Minor Change

A006386237: Development Permit for Material Change of Use
(Special Industry: Hazardous Chemical Facility) and Development
Permit for Operational Work (Filling and Excavation)

07-Aug-2026
Ampol Future Fuels Gasoline Desulfurisation Project
Doc No. XY21024-18-Y09-0157

Client: Ampol Refineries (QLD) Pty Ltd

Figure 2 Proposed Modified West Elevation (Drawing XY21024-02-05-DWG-019, Appendix C)

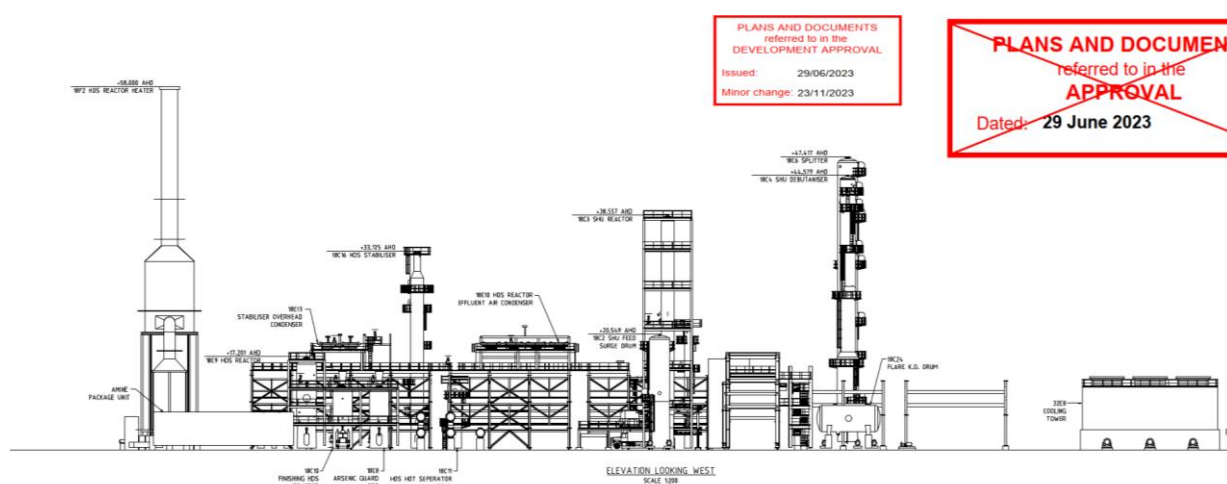
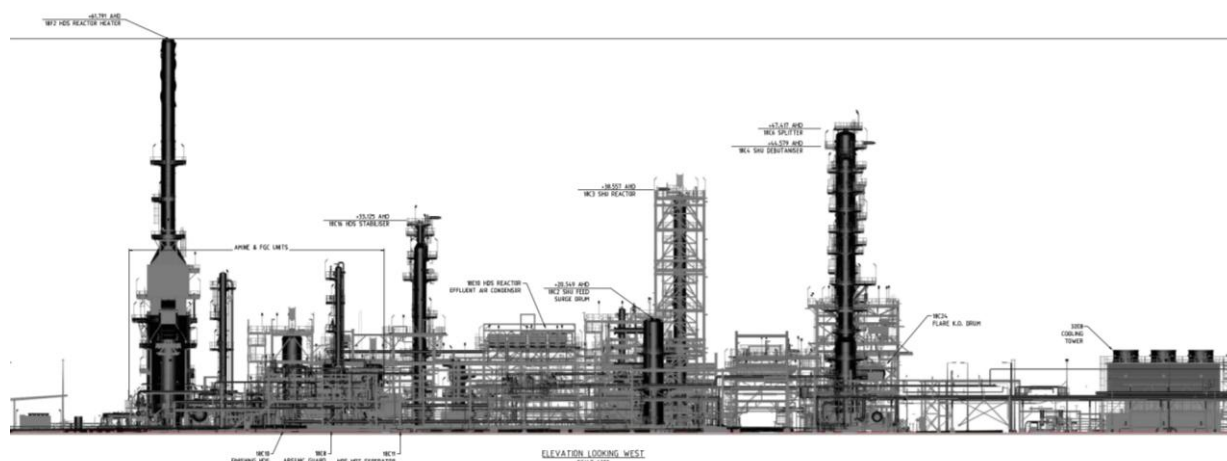
Following vendor selection, it has been confirmed that there have been minor changes to the release parameters for the 18F1/F2 stack. The changes to the original design, as considered in the AQIA and outlined in existing Condition 9, are:

- Increased stack height from 55.00 m to 58.57 m (61.79 m AHD) above ground level
- Exhaust temperature for normal operations reduced from 200°C (473°K) to 195°C (468°K)
- Inside stack diameter at emission point reduced from 2.0 m to 1.6 m through the installation of a stack top cone.

The proposed change to Condition 9 to reflect the constructed design results in a reduction to stack diameter and exhaust temperature as outlined in Table 2. The minor increase in release height (by

approximately 3.57 m) does not impact on existing compliance with performance outcome PO12 of the Industry Code with negligible overall change to scale and design, particularly viewed from the street frontages. This is demonstrated in comparison of the existing approved plan and proposed modified plan in Figure 1 and Figure 2 below.

Figure 4 Proposed Modified Overall Site Plan Extract (Drawing Y21024-02-05-DWG-016, Appendix C)

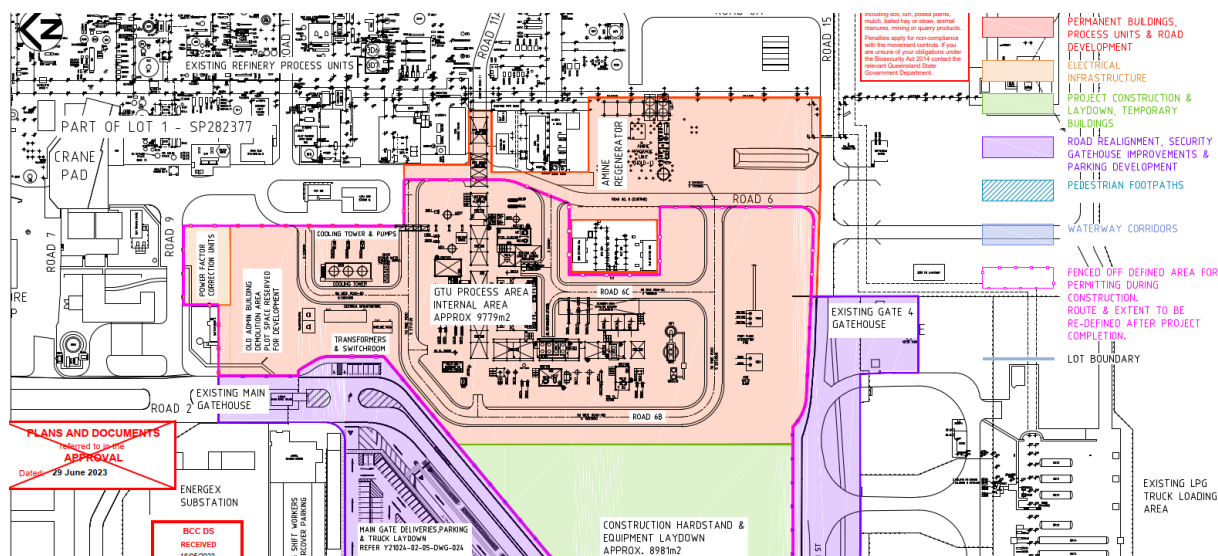
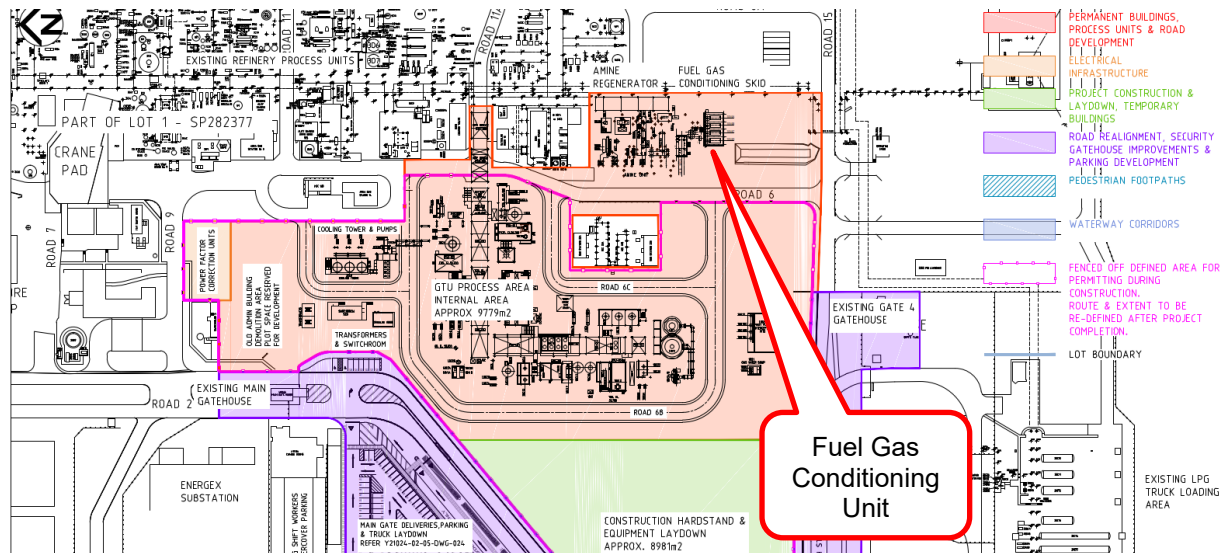
To address this concern, Ampol now proposes the installation of a fuel gas conditioning unit. The conditioning unit would remove the risk of liquid accumulation by chilling the gas using a shell and tube heat exchanger, four chiller units and a water collection boot.

The conditioning unit is to be located on the southern side of the amine unit on the existing hardstand, and remains within the 'permanent buildings, process units and road development' area of the overall site plan as shown by Figure 3 and Figure 4. Figure 4 presents an extract of the proposed modified overall site plan (drawing Y21024-02-05-DWG-016) as included in Appendix C.

The fuel gas conditioning unit remains lower in height and scale than existing refinery structures, and the inclusion will not change the quantity of pollutant emissions to air or the characteristics (e.g. temperature, velocity) of air emission sources.
